150 HOLBORN

DRAINAGE PROPOSALS
BASEMENT PLAN

Drawn By: EP	Checked By: U
Date: MARCH 2016	Scale: @A1 1:125
Drawing No.:	1036010-SK-D.100

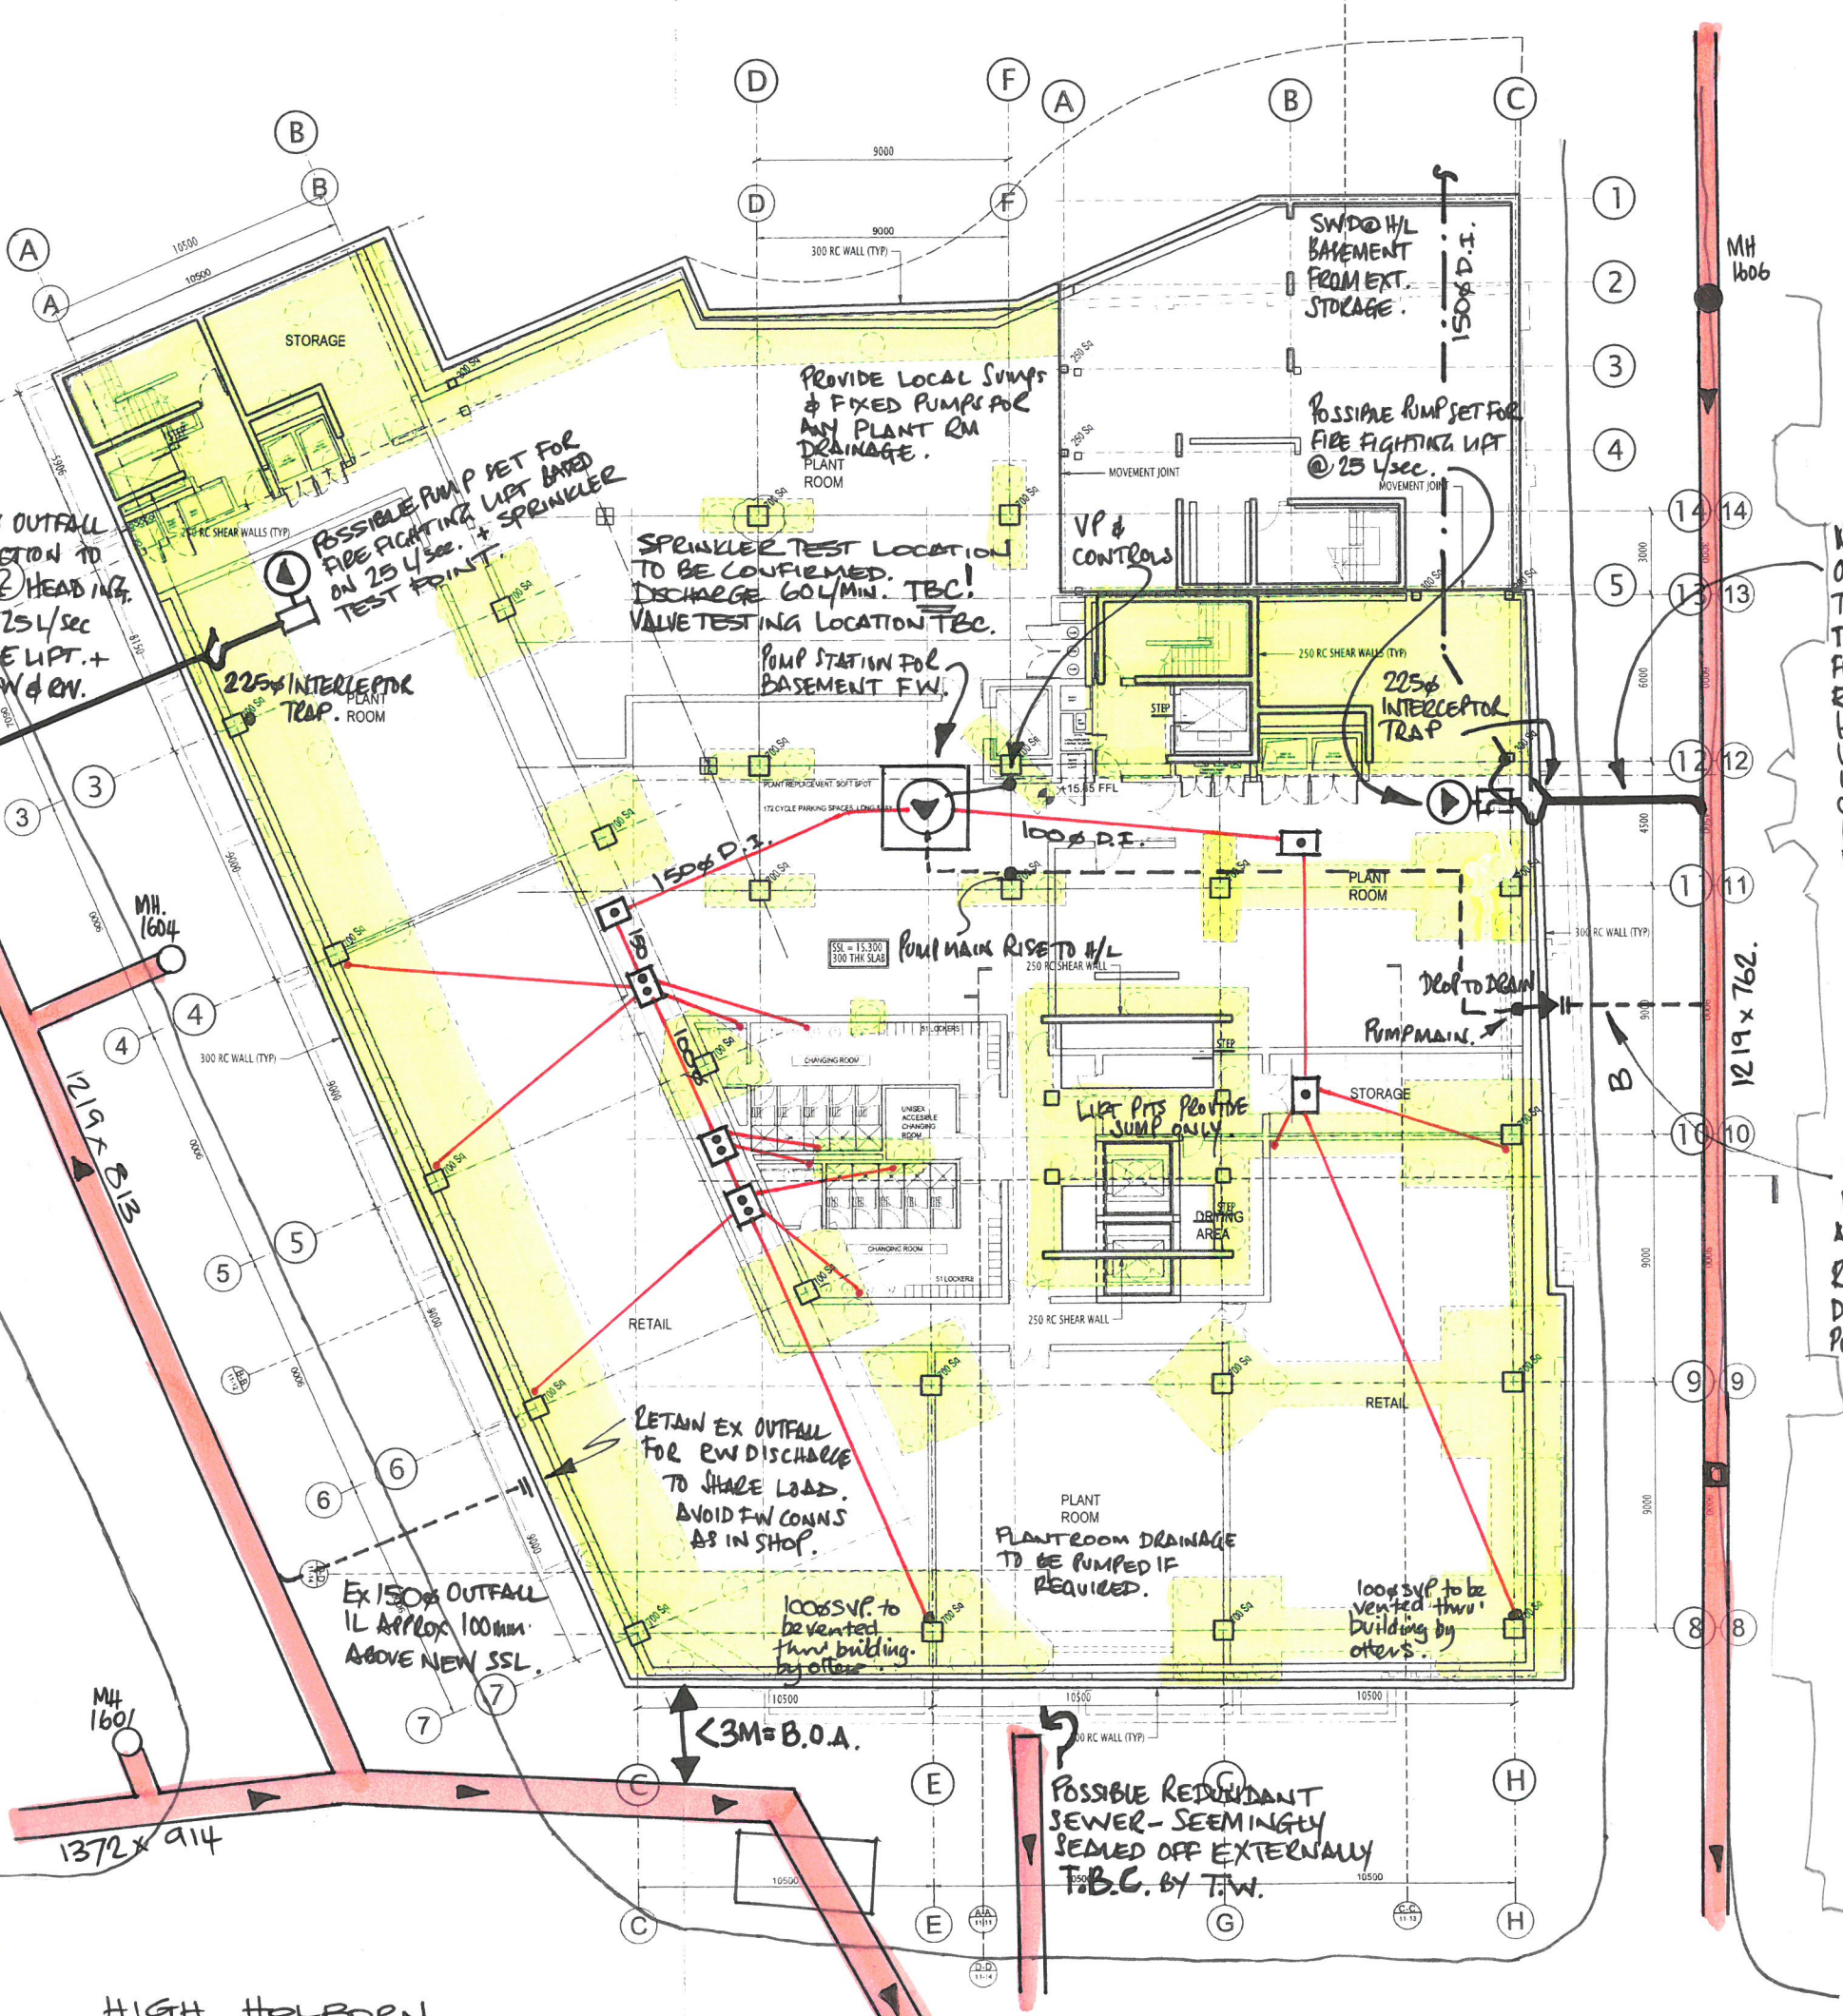
1. FIRE FIGHTING LIFT DRAINAGE (25 L/sec) MAY BE DELEGATED IF ALTERNATIVE METHODS ARE ACCEPTABLE TO OMIT DRAINAGE. FEEDBACK REQ'D FROM ARCH & MEP.
2. CNM ASKED DESIGN FW FLOWS TO CONFIRM CAPACITY OF EX. OUTFALLS. OUTFALL SIZES RECENTLY CONFIRMED BY CCTV SURVEY.
3. EX OUTFALL LEVELS RECENTLY CONFIRMED BY CCTV SURVEY LOWERING OF EX. SLAB PUTS OUTFALLS ABOVE NEW SSL.
4. EX OUTFALL CONNECTION IN RETAIL AREA NEEDS TO BE CONFIRMED AS ACCEPTABLE TO CLIENT & FUTURE TENANTS IN TERMS OF LEGAL ACCESS & FUTURE MAINTENANCE.

NOTE.
ALL DRAINAGE UNDER BUILDING TO BE DUCTILE IRON AS ST. GOBAN.
IL'S OF NEW SEWER CONNS YET TO BE ENGINEERED BUT COULD BE ABOVE BASEMENT F.F.L.
<3M = B.O.A.
CONFIRM THAT SEWER IS MORE THAN 3M AWAY FROM NEW WORKS OR A BUILD-OVER AGREEMENT WILL NEED TO BE Sought FROM THAMES WATER.

NEW 225Ø SEWER OUTFALL & CONNECTION TO SEWER VIA HEADING TO SERVE 25 L/sec FROM FIRE LIFT + RESI FW & RWP + OFFICE FW.

EX 150Ø OUTFALL IL APPROX 100mm ABOVE NEW SSL. RETAIN FOR RWP DISCHARGE & FW PUMP SET FOR BASEMENT.
